Land at Junction 22 of the M1,

Cliffe Hill Farm

Response to Additional LLFA Comments

Document No: 30206-BGL-XX-XX-TN-D-00002

Section Pictures - 16/01/2026 - Headwall 1X

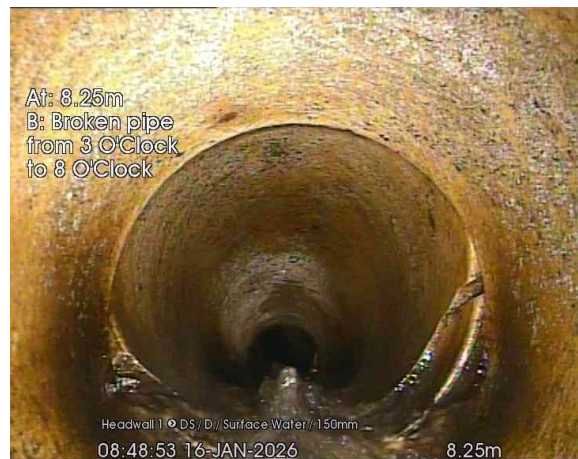
After completing the inspection, we found that that the header wall downstream requires 3 x 150mm epoxy patch repairs at 3.67m, 8.25m and 10.89m to seal broken sections of pipeline.

As previously referred to, a CCTV survey condition report is attached for all the offsite pipes along with a plan annotated with relevant references. This report highlights required remedial works. We would be happy to accept a condition which requires the limited remedial works highlighted in the report to be completed.

Section Pictures - 16/01/2026 - Main LineX

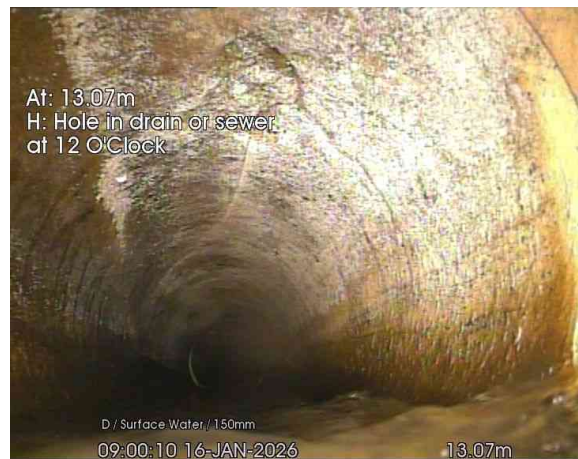
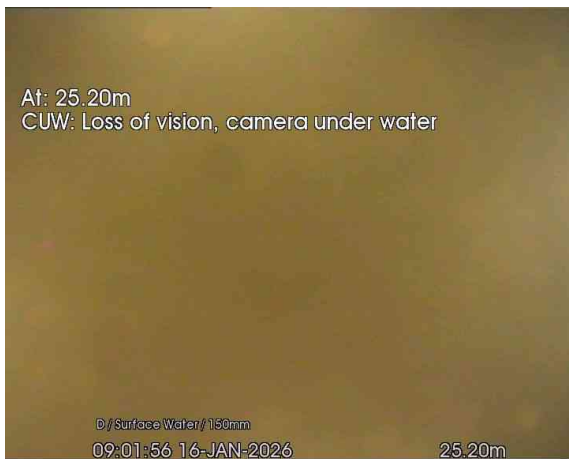
Main line downstream has a hole in the line at 13.07m and a fracture at 17.17m. These should ideally be sealed using 2 x 150mm epoxy patch repairs. Line also holds water at 22.05m, the camera was under water. |Survey abandoned at this point.
